Office Action Summary	Application No. 10/576,215	Applicant(s) CORTNEN, DAVID MAGDA EDDY	
	Examiner WILLIAM MCCALISTER	Art Unit 3753

DETAILED ACTION

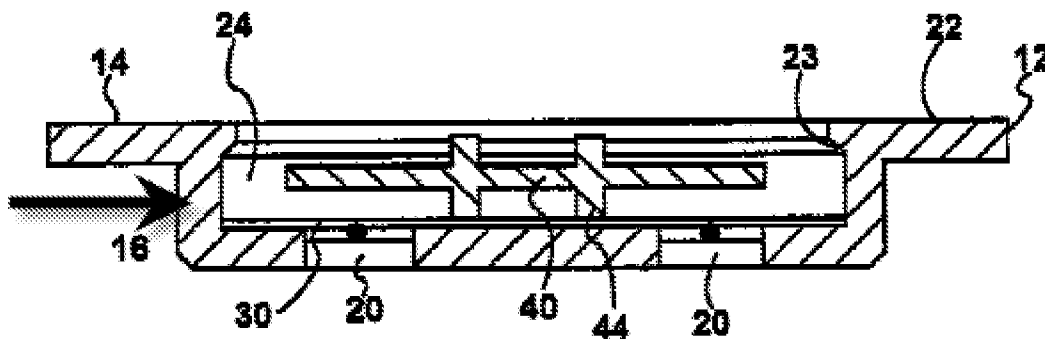
6. Claims 1-3, 5, 6, 9-15, 17, 18, 21 and 22 are rejected under 35 U.S.C. 112, second paragraph, as being indefinite for failing to particularly point out and distinctly claim the subject matter which applicant regards as the invention. Claims 1 and 13 require "a side wall extending radially from said open end to said closed end..." The only wall between the open and closed ends is illustrated with an arrow in the Figure below.

This wall is cylindrical, with its cylindrical axis extending vertically from the open end to the closed end (i.e., from top to bottom as depicted in this Figure). That is, the wall extends in an axial direction from the open end to the closed end. How does the wall extend radially from the open end to the closed end?

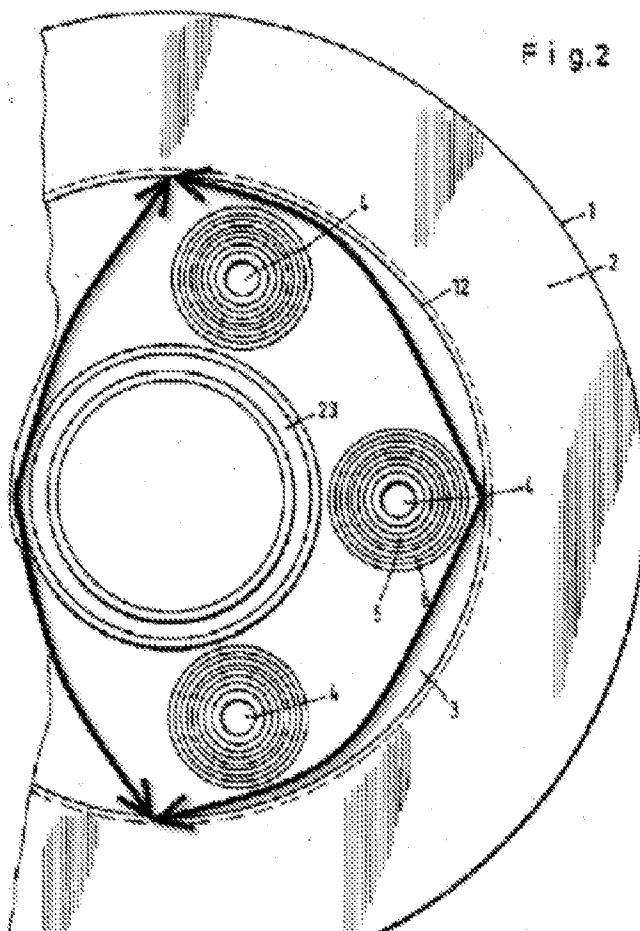
Hollenstein discloses the closed end to have a planar surface (valve seat 3; FIG 2), wherein the planar surface extends between opposite sides of said inner wall surface of said side wall (as illustrated in annotated FIG 3 below). As can be seen, the phrase "extends between" does not preclude the interposition of non-planar surfaces (4, 5, 6, 23), since planar surface 3 extends around the non-planar surfaces.
